ADDENDUM NO. 4

BURKESVILLE WASTEWATER TREATMENT PLANT IMPROVEMENTS CITY OF BURKESVILLE, KY

GRW PROJECT NO. 4667

July 16, 2020

DATE: JUNE, 2020
 SCALE: AS SHOWN
 SHEET NO. E-01-103

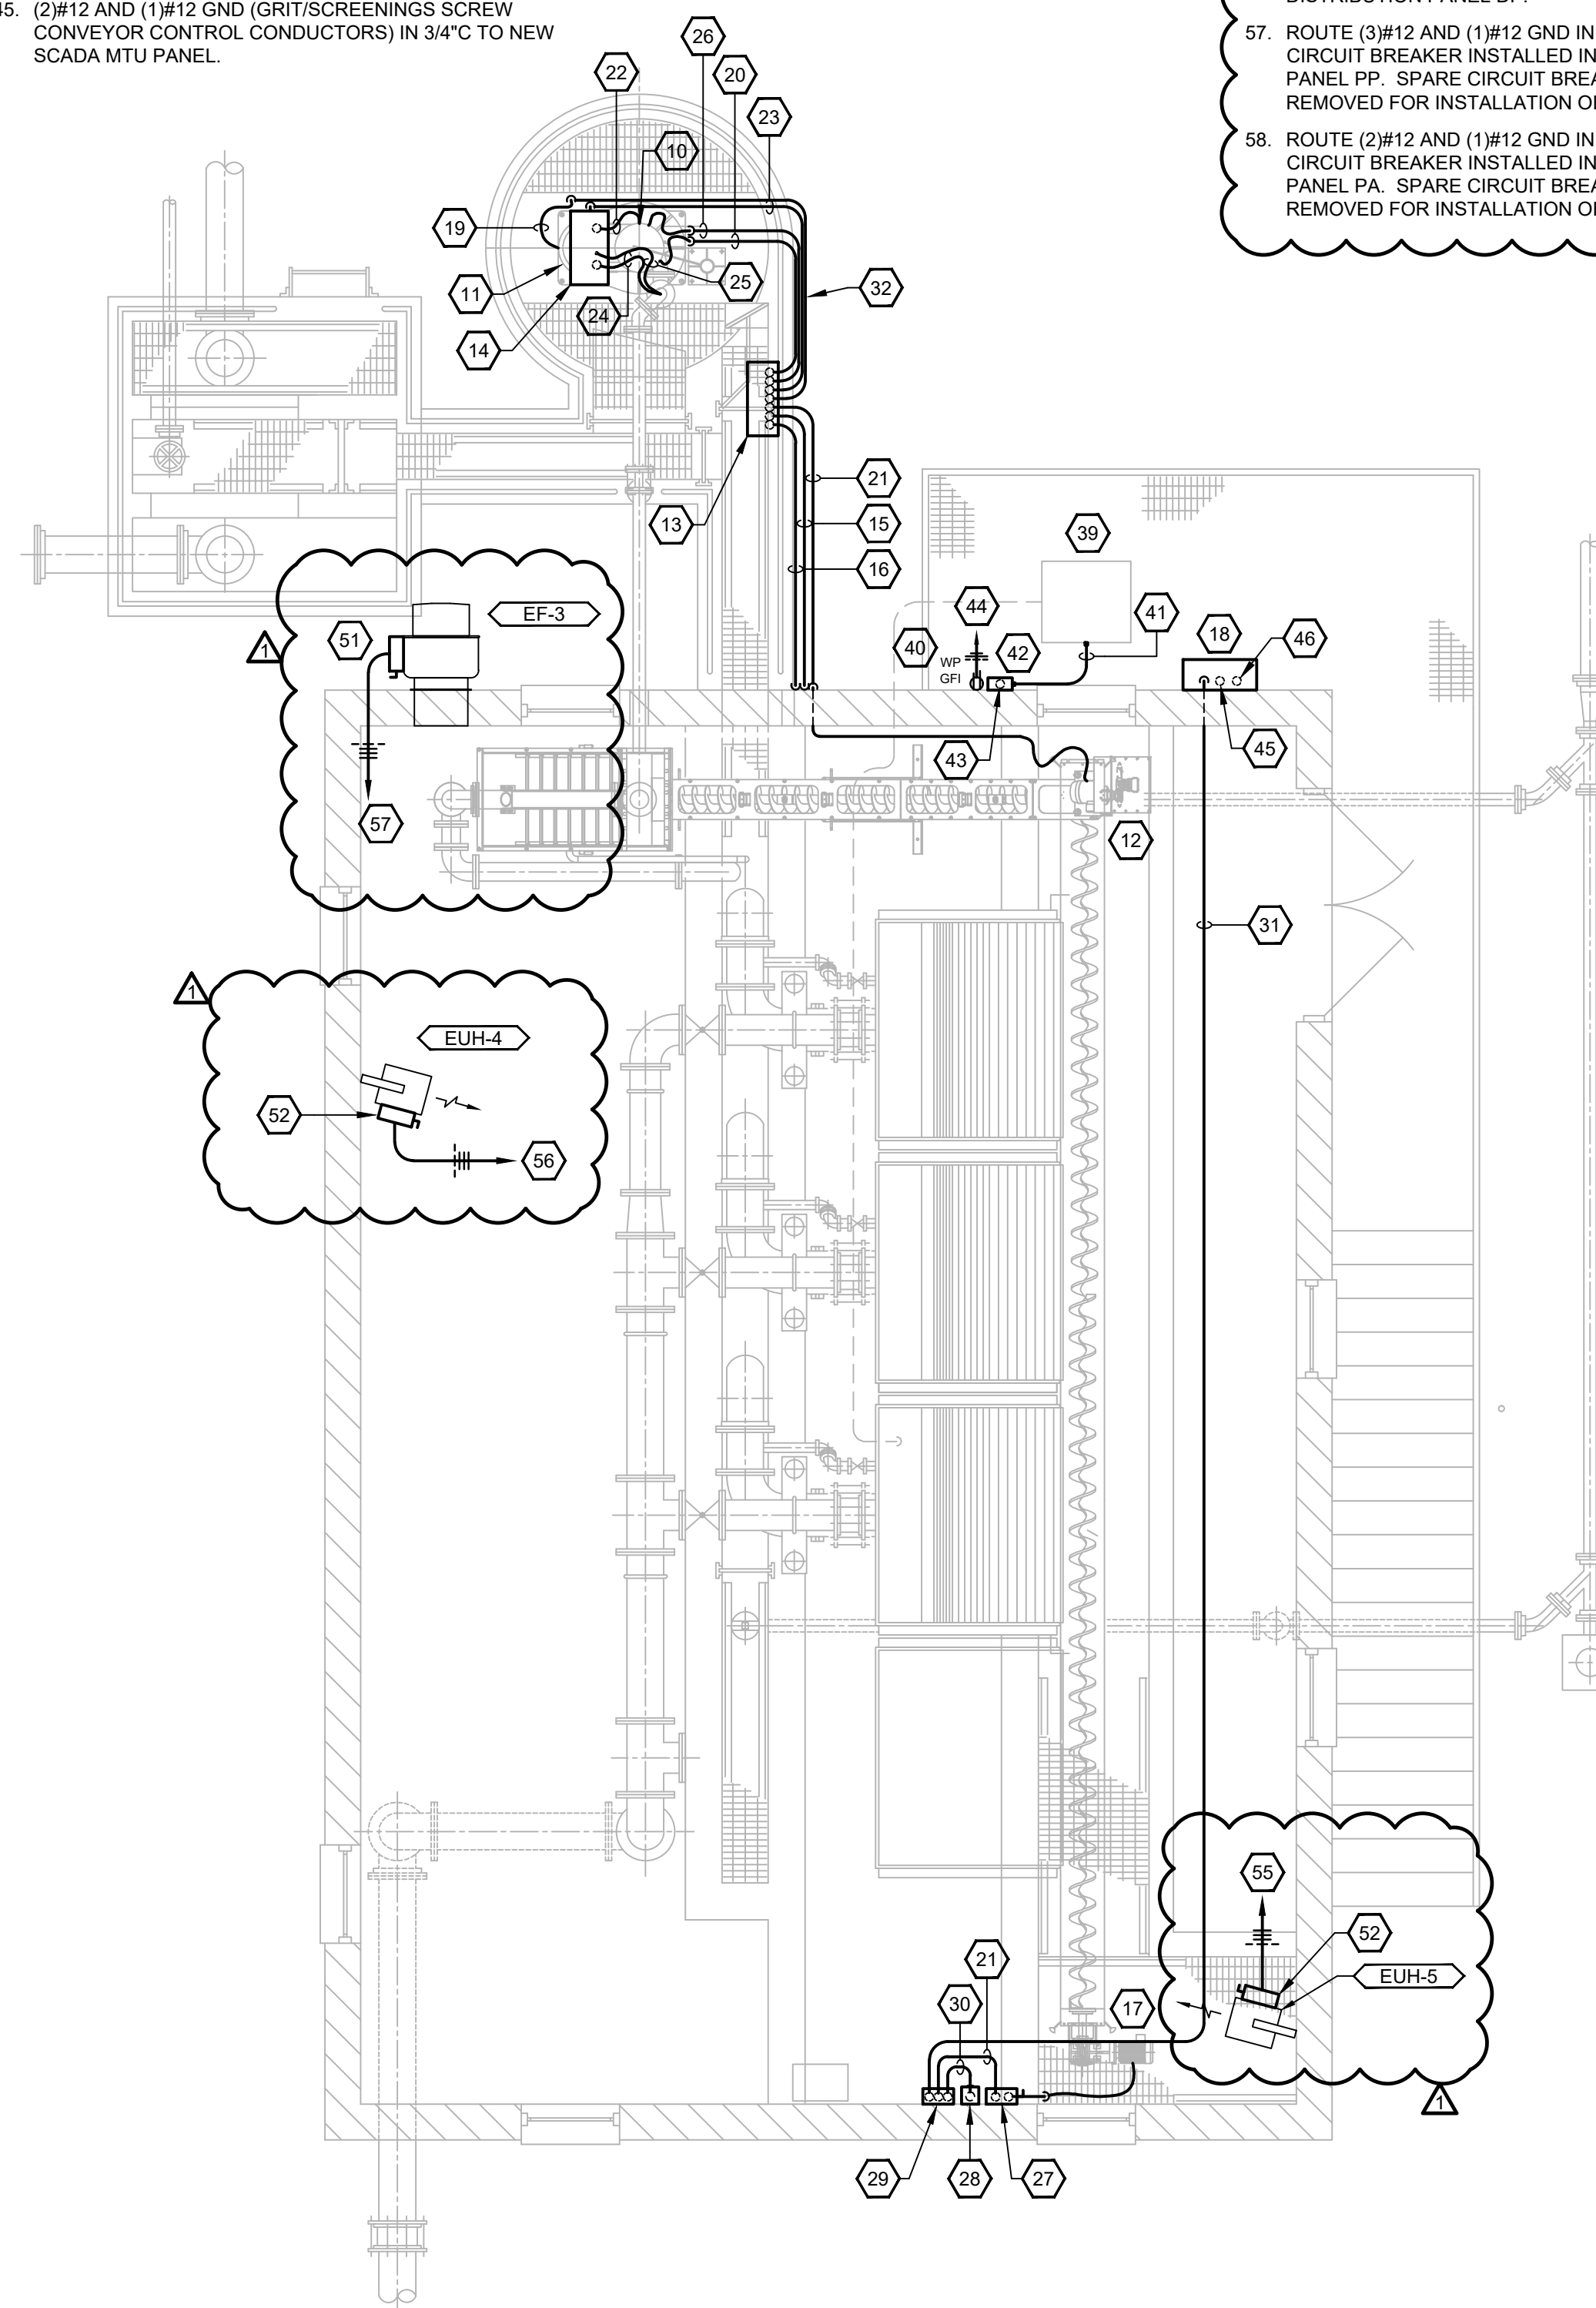
2. **DRAWING – SHEET E-01-103**

B. Drawing E-01-103 shall be replaced with revised addendum drawing included herein.

- Note the areas shown clouded. Electrical devices and circuits have been added for new HVAC equipment.
